**NSLPP MEETING HELD ON 07/09/2022****SECTION 4.55 APPLICATION REPORT****Attachments:**

ADDRESS/WARD: 372 Military Road, Cremorne**APPLICATION No:** D269/21/2**PROPOSAL:** Section 4.55(2) application seeking modifications to Development Consent (D269/21) including various amendments to the deferred commencement approval for a five (5) storey mixed use development.**PLANS REF:**

OWNER: Canopy Investment Holding Pty Ltd**APPLICANT:** Platino Properties Pty Ltd**AUTHOR:** Robin Tse, Senior Assessment Officer**DATE OF REPORT:** 30 August 2022**DATE LODGED:** 21 June 2022**RECOMMENDATION:** Approval (In-part)

DRAWING SET ID:	DA 102	ISSUE D
SUBSET: DA PLANS		
DRAWN BY: WH		
FILE: PAR75 6.pln		
NOMINATED ARCHITECT	GEORGE REVAY REG. NO. 3954

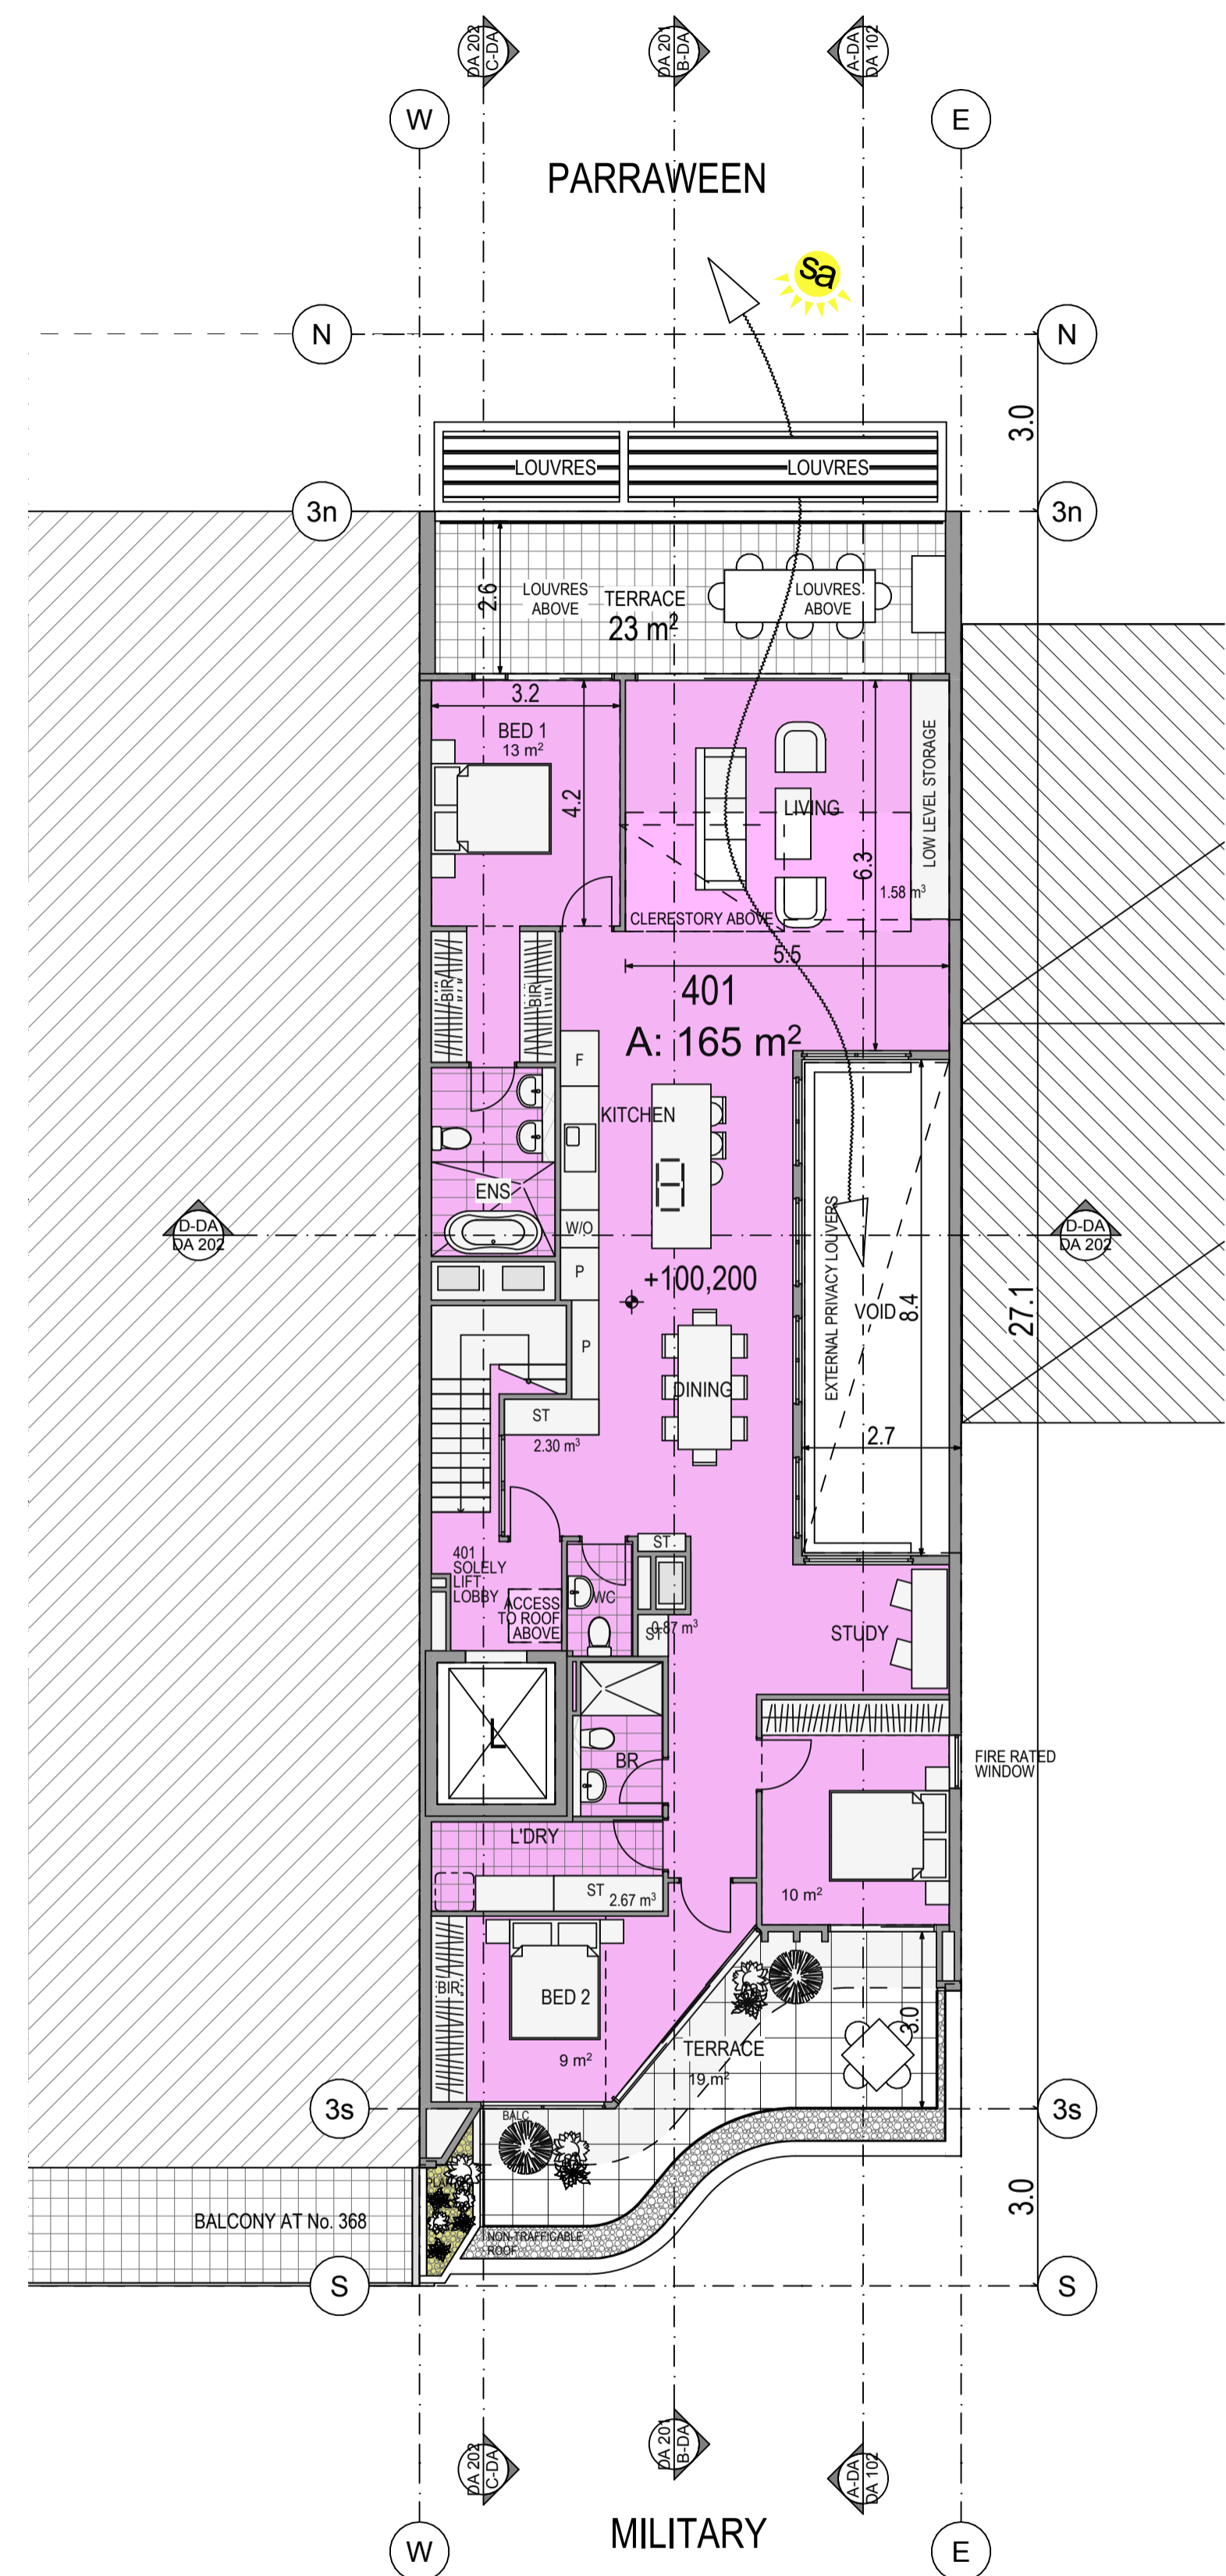
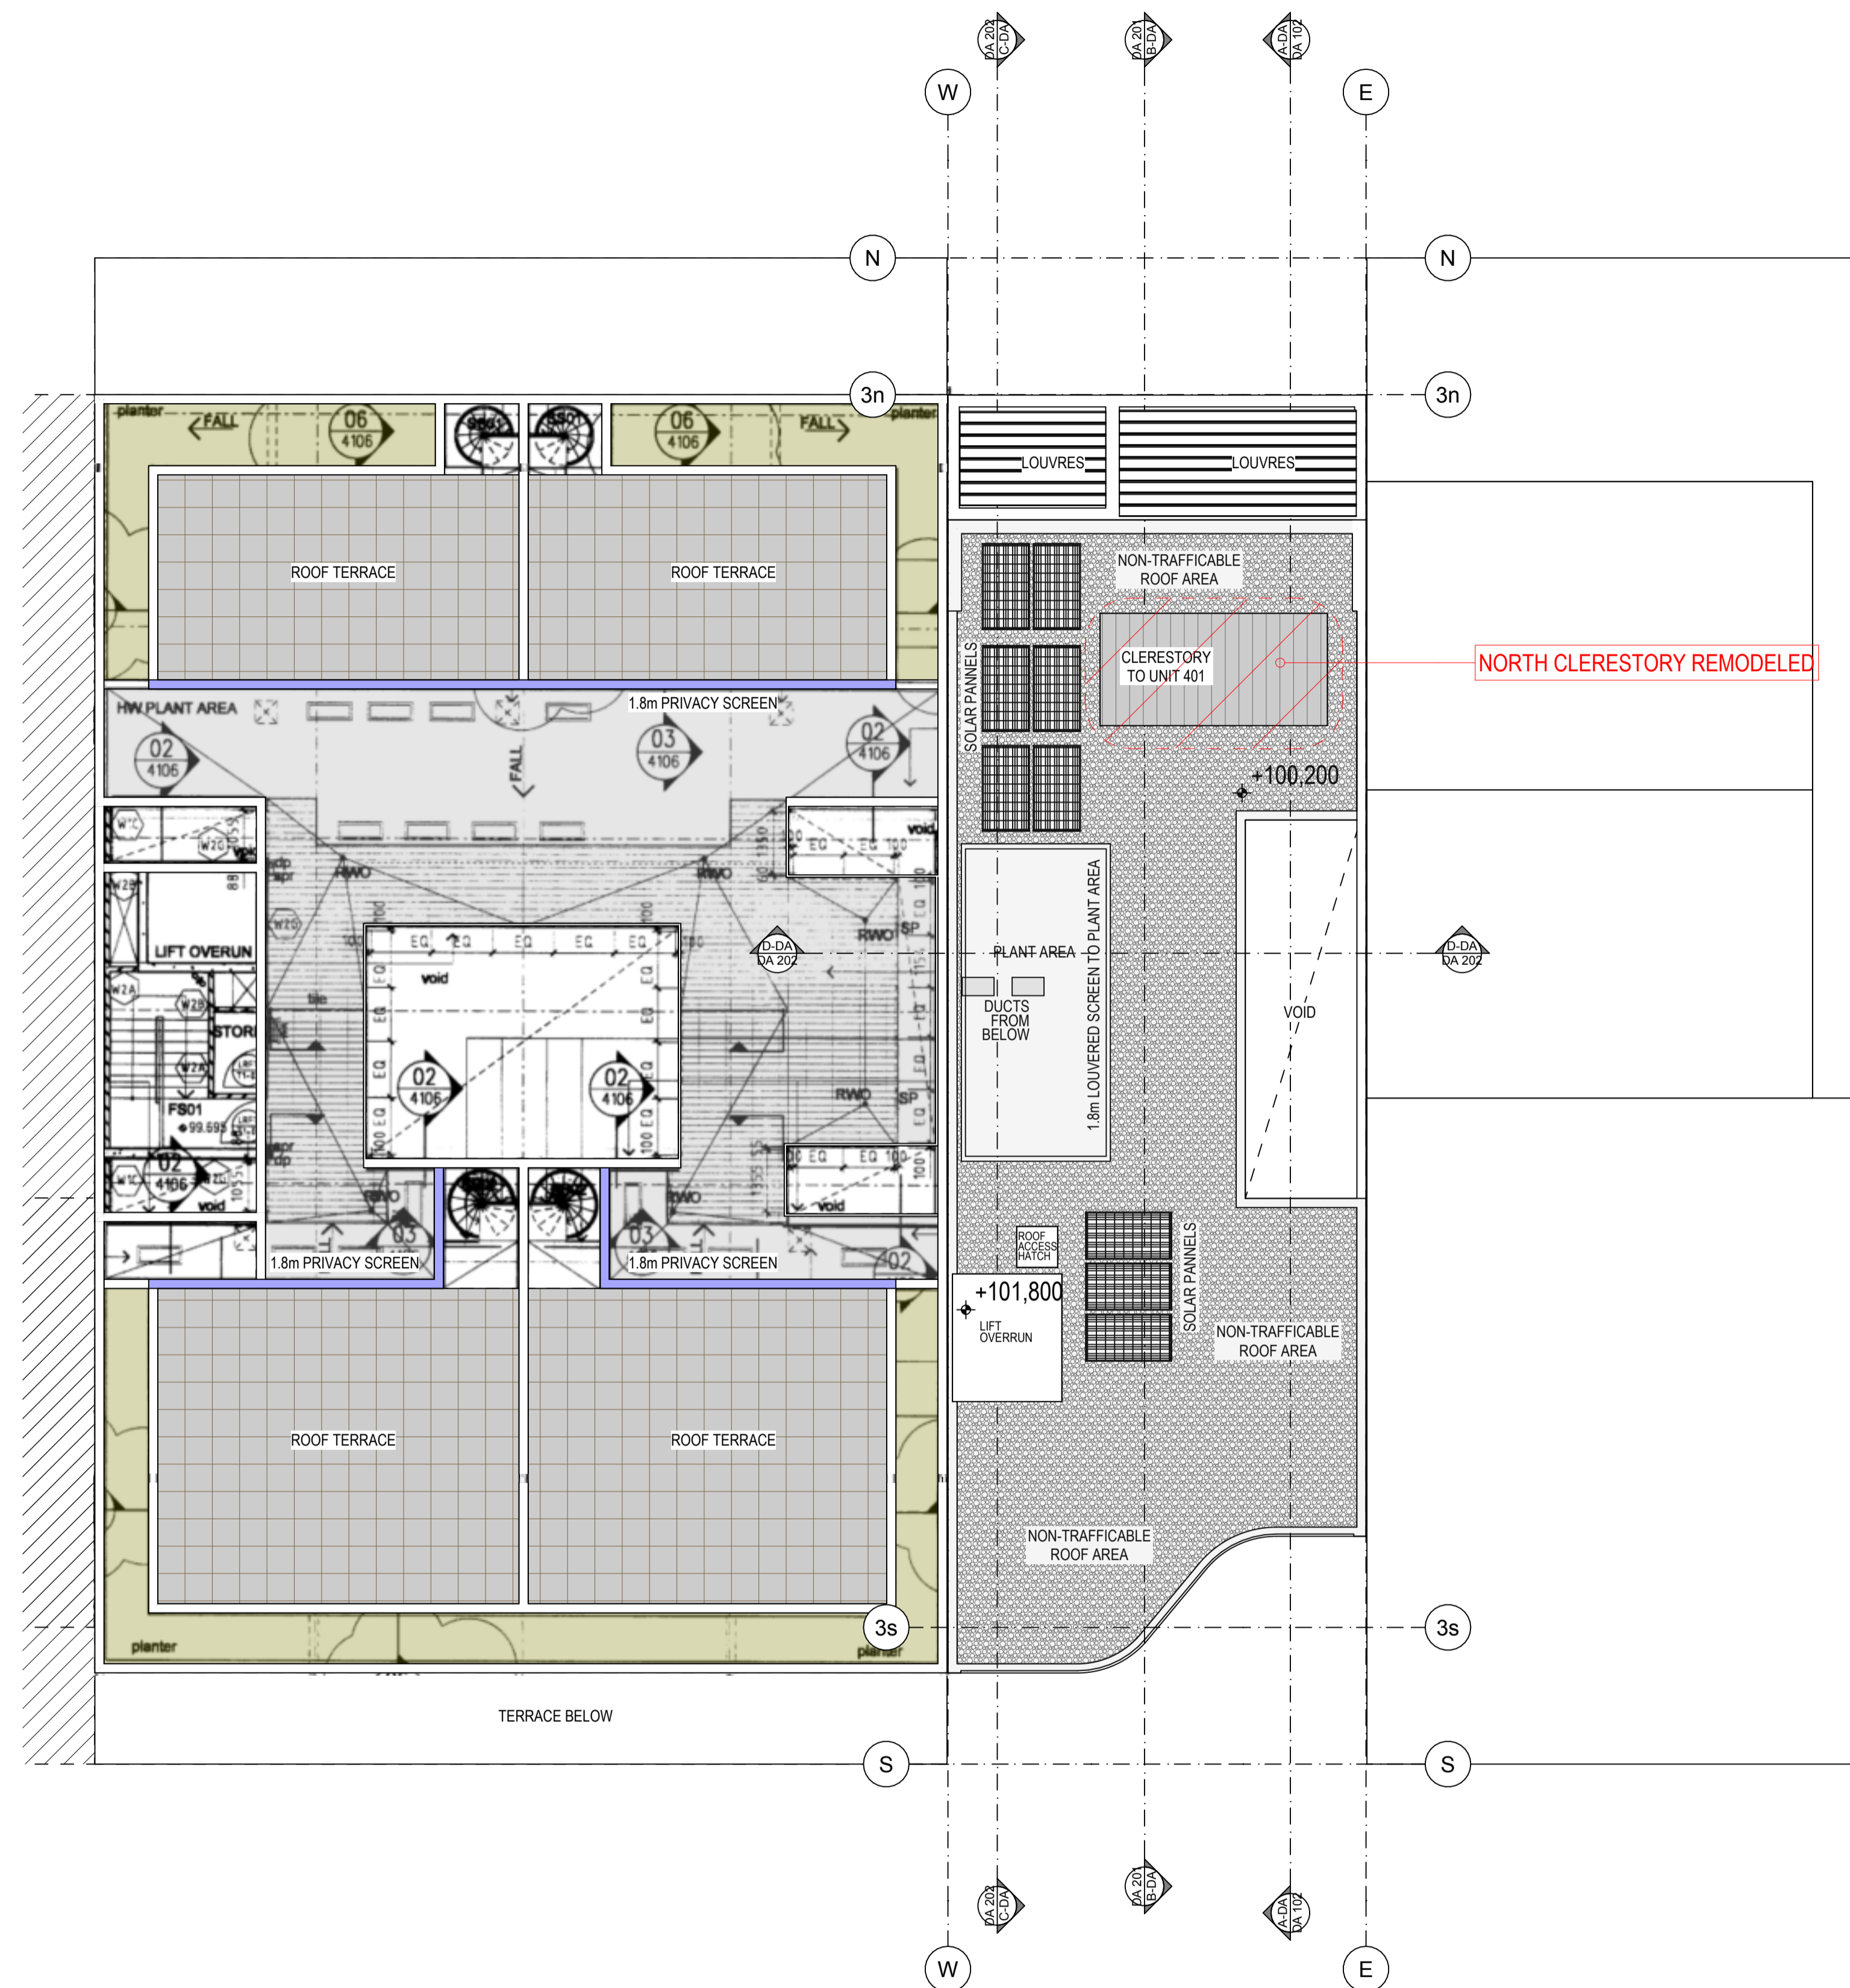
- Modifications to the clerestory windows on the roof level, including the removal of the clerestory windows from the southern side of the roof and reduction in the size of the clerestory windows on the northern side of the roof, as shown on Drawing DA102 Issue D, dated 19/07/22 and prepared by PA Studio.

SOUTH ELEVATION WITH NEIGHBOURS

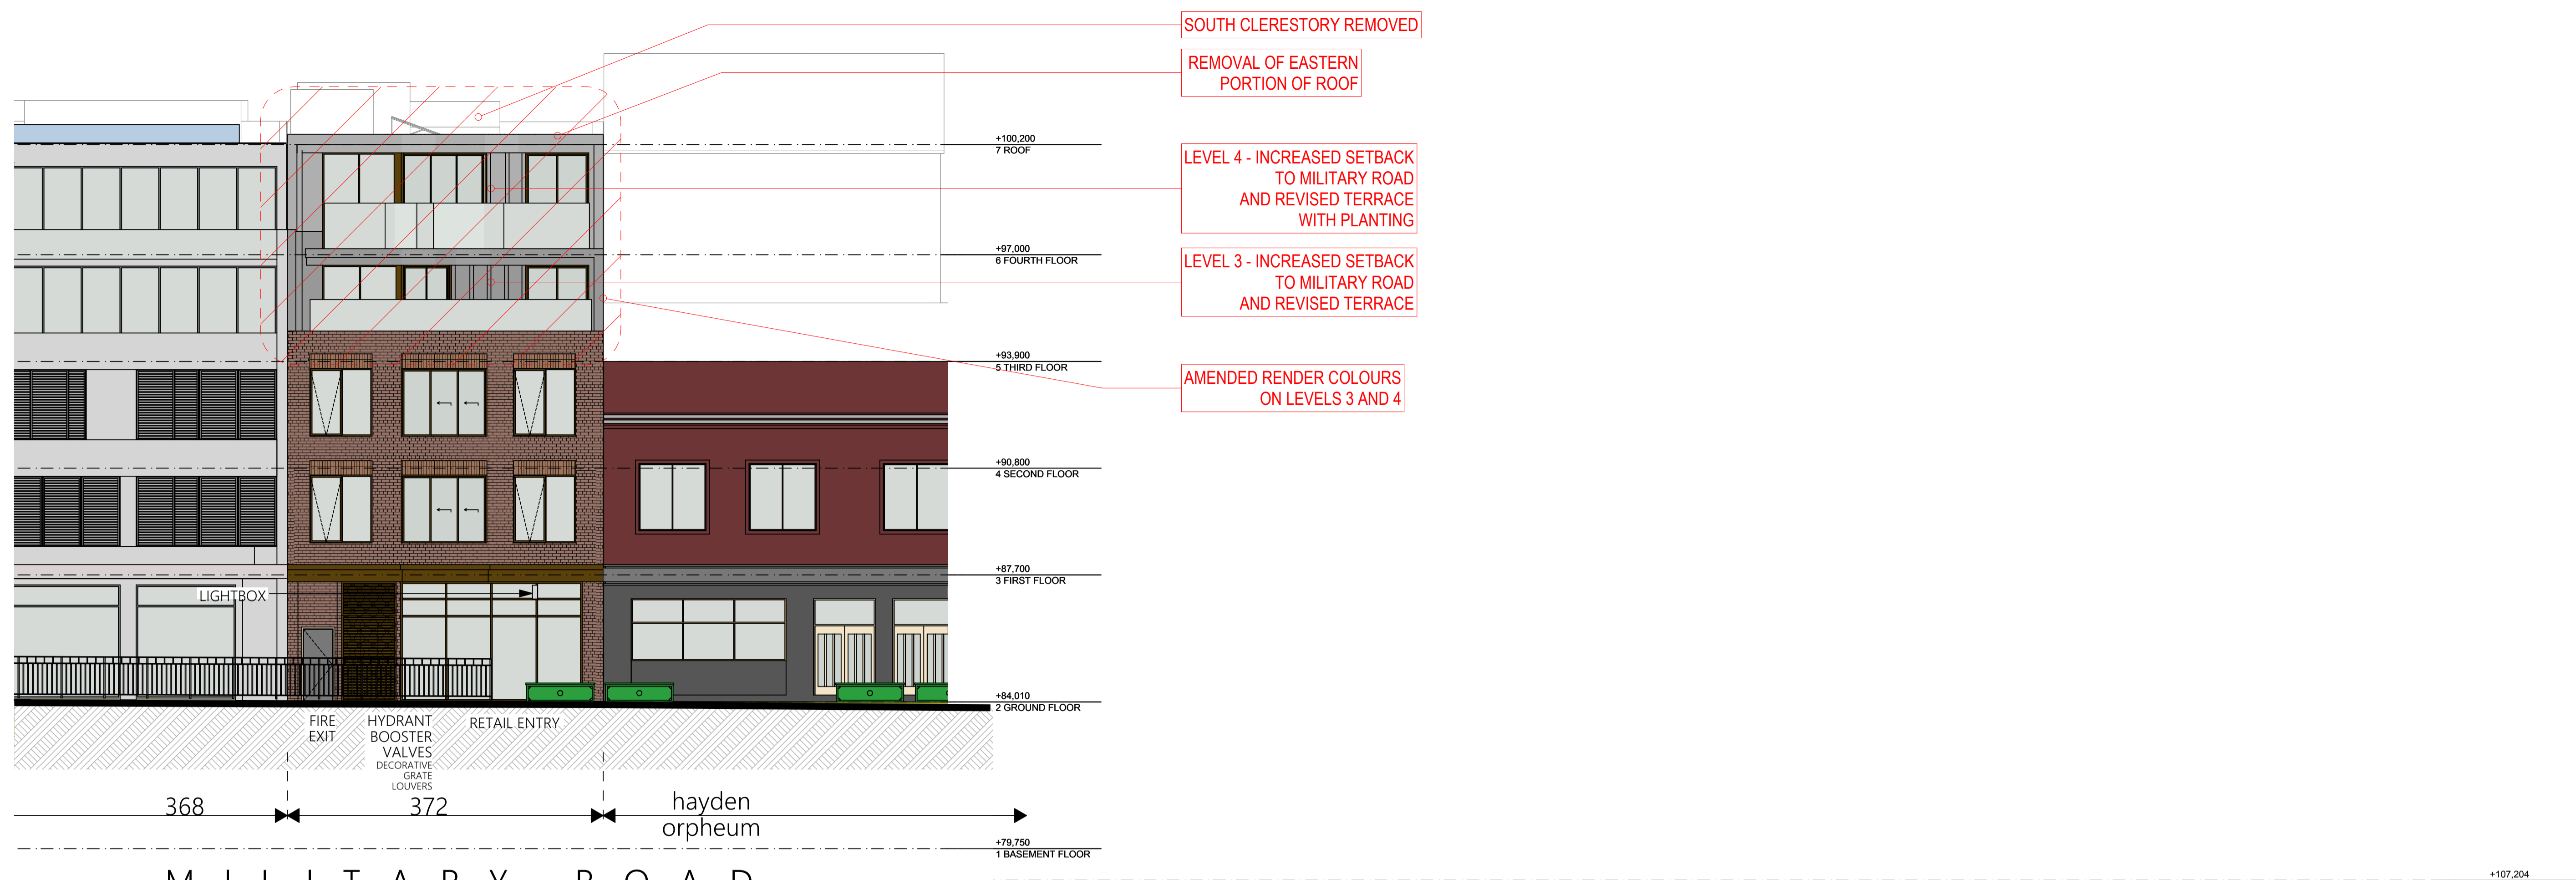
It is therefore considered that the proposed modifications to the southern façade for Levels 3 and 4 are not supported because the proposed modified design does not promote the character of the area.

The proposal for modifications to the design of the southern (Military Road) façade on Levels 3 and 4 is contrary to the key reason for granting deferred commencement approval of the original application because the modified design does not provide a respectful transition in building heights, built forms, building bulk and scale between the group of buildings along No's. 358-398 Military Road, including the subject site, and the heritage listed Orpheum Theatre. This aspect of the subject Section 4.55 application is not supported.
